Permit Plans (8-4-22) Fire Station 19 (Markups & Markup Summary).pdf Markup Summary

LS-1 Landscape Plan (7)

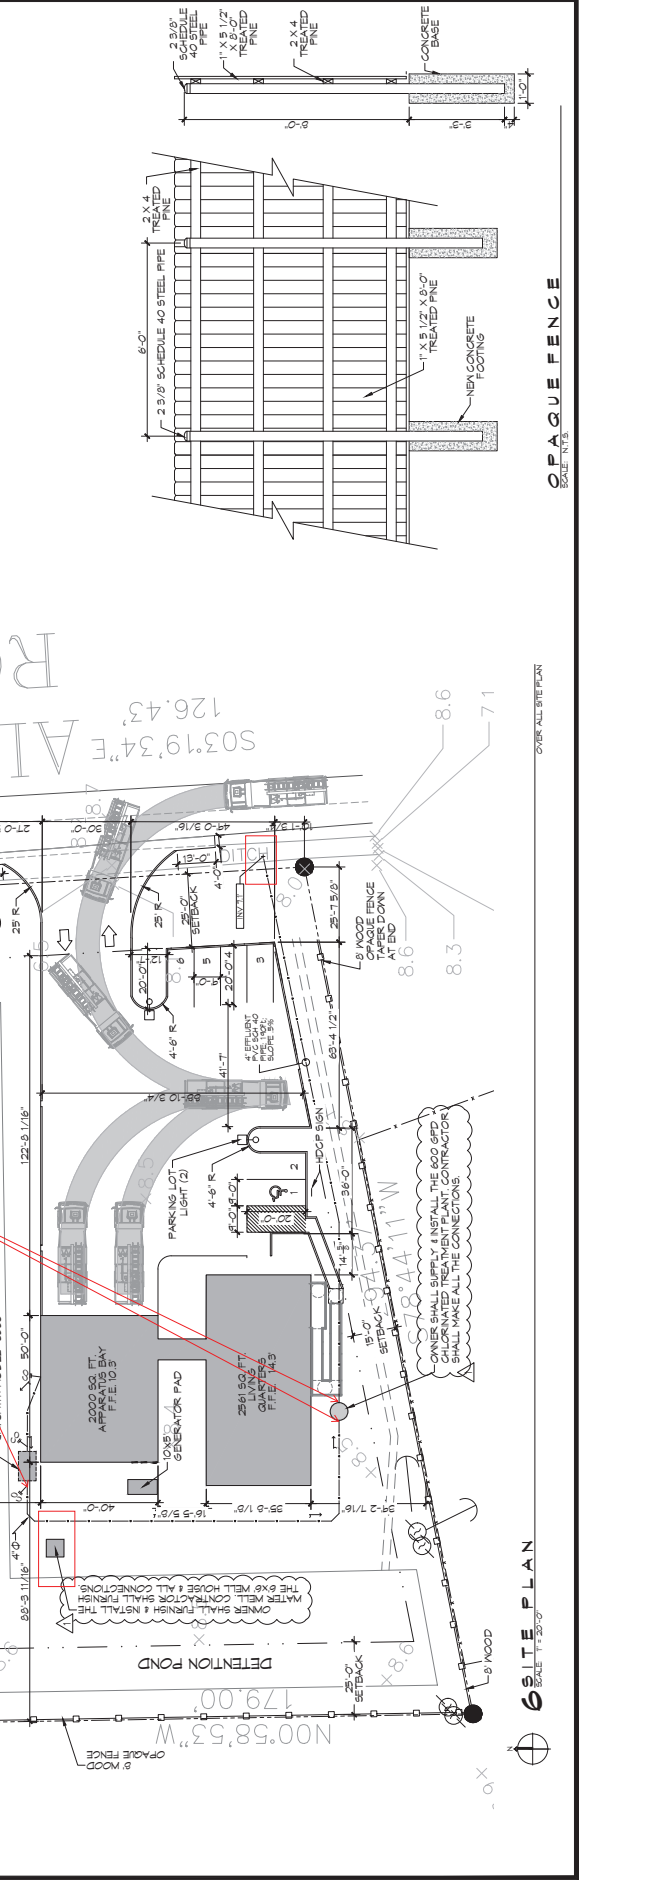
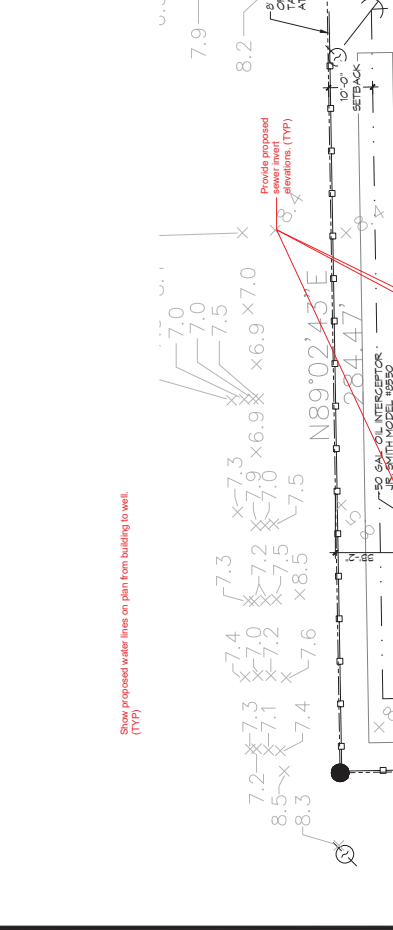
Planning Comments:
 1. A Land Clearing Permit is required prior to removal of any trees 6" caliper or larger.
 2. Provide recorded cash sale and survey. This is required prior to approval of land clearing permit, sitework or building permit.

3. Locate dumpster to be enclosed by 7' opaque fence & gate on plan or note on plan if refuse containers will be maintained inside of the building only.

4. Lighting plan must be provided which conforms with UDC Section 130 Division 4 Outdoor Lighting Regulations. Show light locations and verify that they do not conflict with required landscape islands in parking lot.

5. Coordinate utilities, civil and landscape package to avoid conflicts with existing and proposed trees per code. Typical.
 6. Label detention pond on LA plan (if any). Verify that 5' flat space is provided around the edge of the detention pond as required by UDC.

7. Impact fees may apply. Verify with Planning.
 8. Signage is by separate permit and must comply with UDC Section 130 Division 3- Sign Regulations.

Please add call-out for 8' opaque fence which is required where property abuts residential zoning.

Label Detention Pond on plan

Complete
